Alton Coal Development, LLC

Subject: **Drainage Control Adjustments, Task ID #4101 and Alluvial Groundwater Management Plan, Task ID # 3998 Coal Hollow Project, Kane County, Utah, C/025/0005**

Alton Coal Development, LLC is providing this submittal addressing a deficiencies requested in Task List 4101:

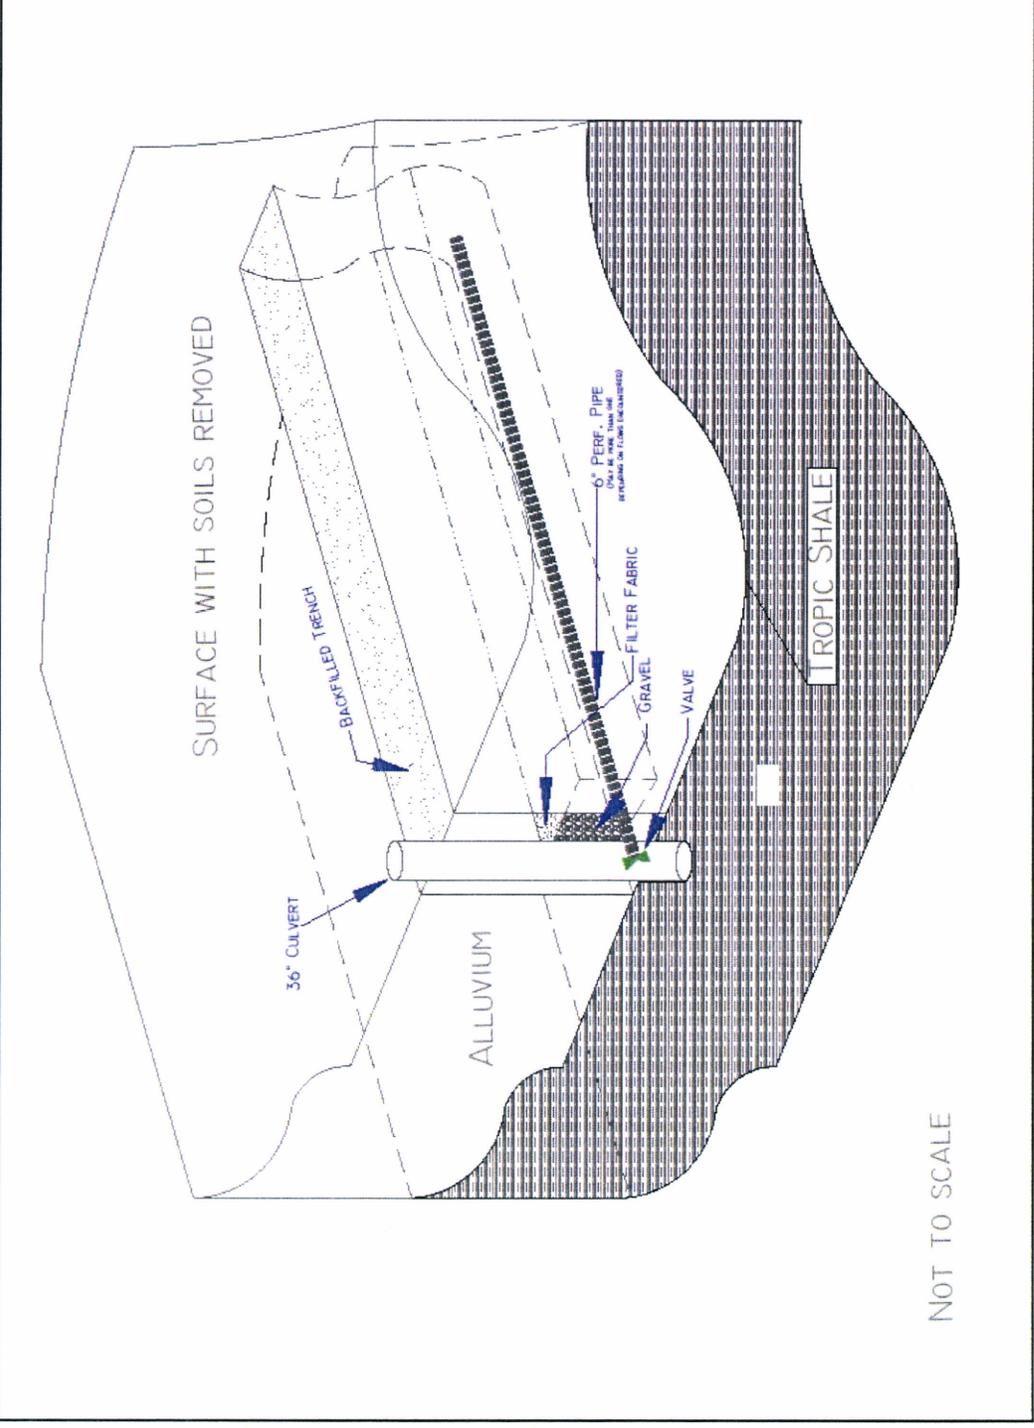
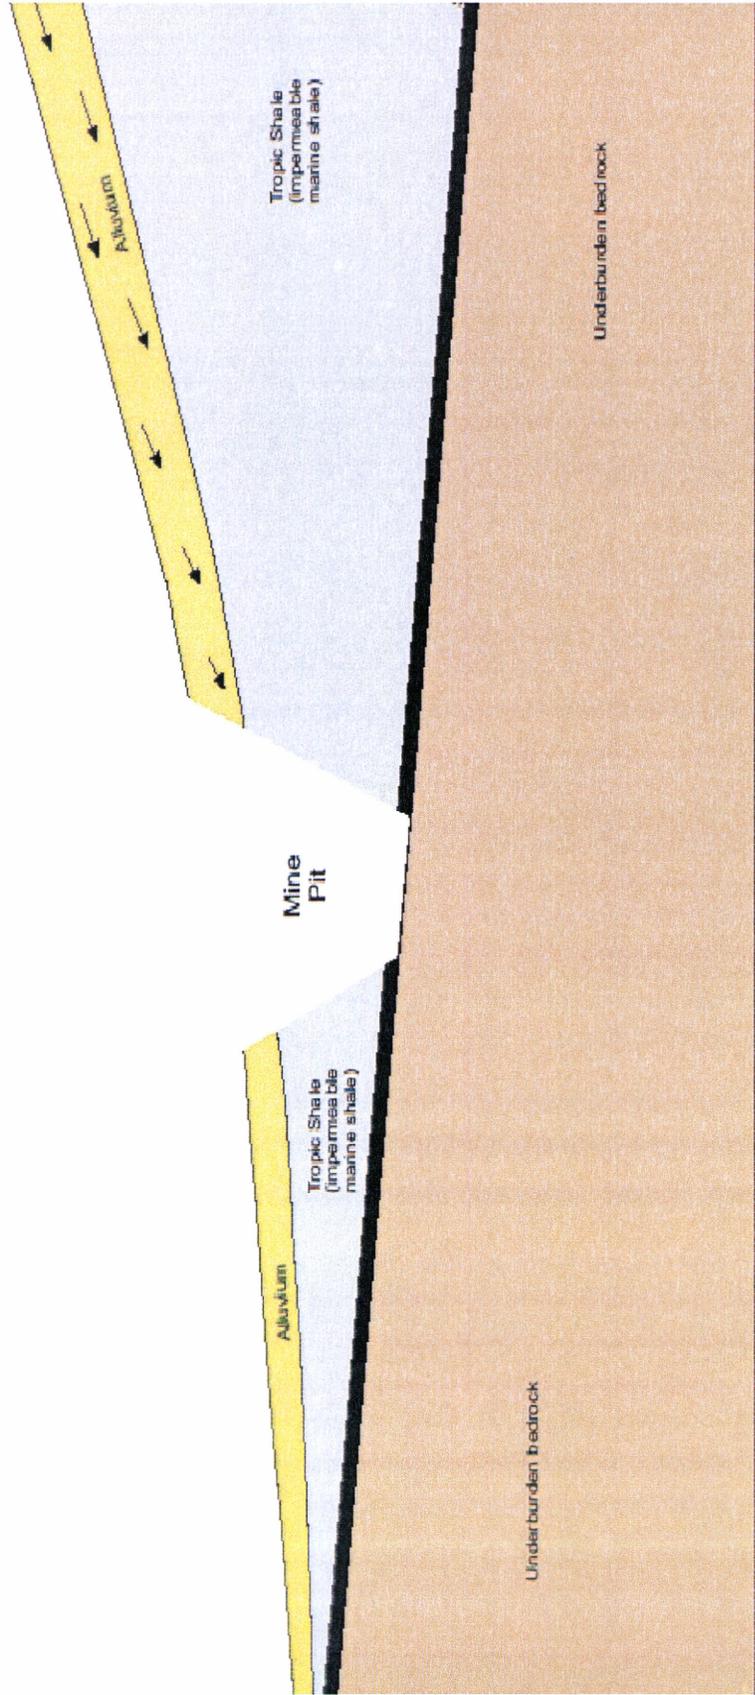
- **R645-301.533.712; .526.155**. Figure 1 of the application includes anticipated design details for the perforated pipe and culvert system (de-watering well). The Division requires that a more complete standard design for the system be provided. The standard design must include all pertinent data with anticipated dimensions of all aspects of the system, construction requirements, as well as all pertinent drawings, cross sections, etc. The applicant must remove all language from the application indicating the designs of the system may vary based on site-specific conditions. Any deviations from the standard design must be submitted to the Division as amendments to the MRP.

Alton Coal Development, LLC will provide to the Division a map showing the area where interceptor drains are proposed for construction at such a time as these become necessary. Alton Coal Development, LLC will provide to the division an updated copy of this map within 15 days of the construction of any alluvial groundwater interceptor drains. The map will include a legend with details on construction specifications in relation to the standard design. Text has been added to the Alluvial Groundwater Management Plan to reflect this commitment.
